APPENDIX 6

HCC PRE-APP CORRESPONDENCE

From: FWM Statutory SWM Consultee mailbox <SWM.Consultee@hants.gov.uk>
Sent: 18 November 2025 12:21
To: Tommy Ashby
Cc: Chris Hendry
Subject: RE: SWM-PRE/2025/0502 Goodwillies Timber Yard - Report [Filed 19 Nov 2025 14:55]

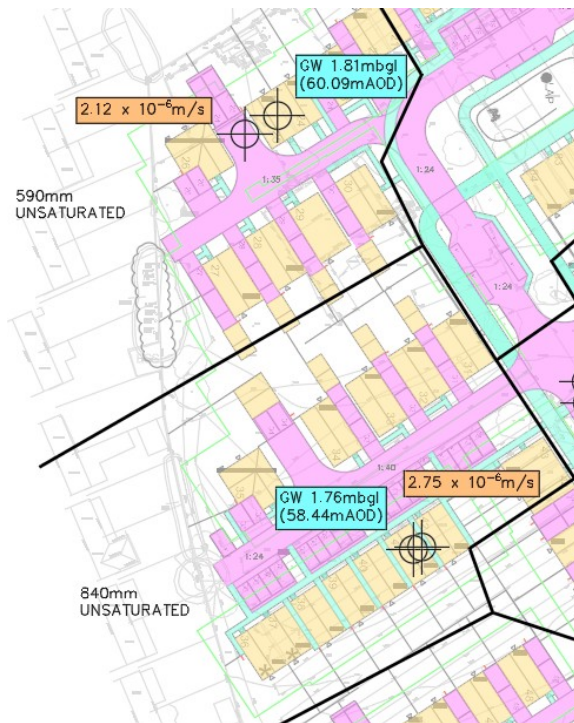
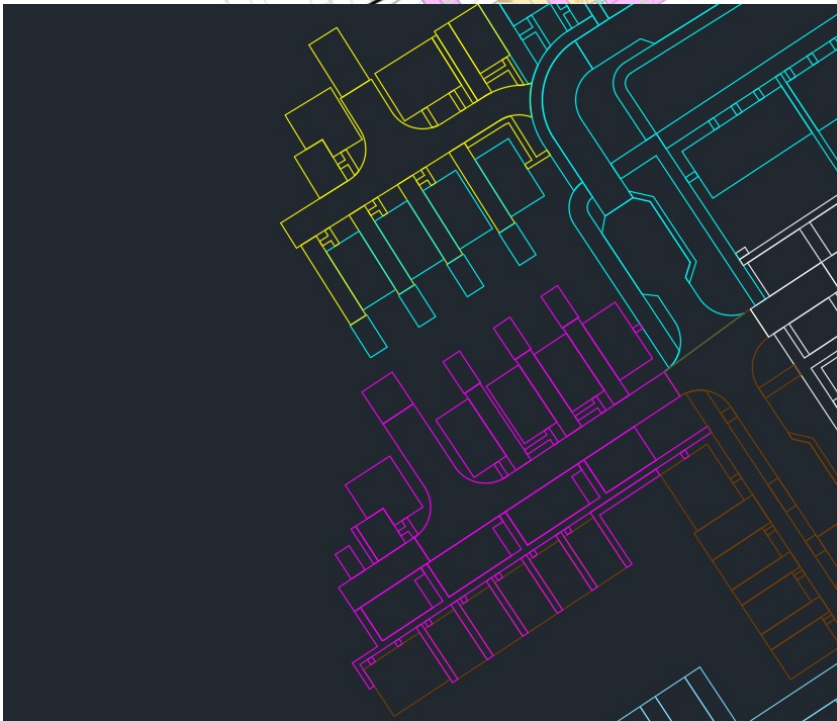
It was raised that the drainage strategy would be revised to apply the various infiltration rates based on logical but conservative “zones” across the site. As part of that exercise, we can then determine that the design satisfies the 1m depth of unsaturated soil below the permeable paving. However, I have encountered two areas where currently the 1m depth requirement is not satisfied:

When applying the infiltration rates shown in orange to the approximate catchment area indicated by the black lines (see adjacent image for detailed catchment plan in the area) and then comparing the relationship of the proposed ground level, subbase invert level and recorded GW level, we are left with the unsaturated soil depths indicated. Please note that we have assumed a minimum subbase depth of 600mm to ensure that drainage at the back of houses can enter the permeable paving via a diffuser unit at appropriate gradients.

Thank you for the additional information. Having read the groundwater report I would agree that the extremely shallow figure is an anomaly and not representative of the site. Given that this is a perched water table and the testing was undertaken after heavy rain, I would be willing to accept the reduction in unsaturated zone in the 2 areas outlined below.
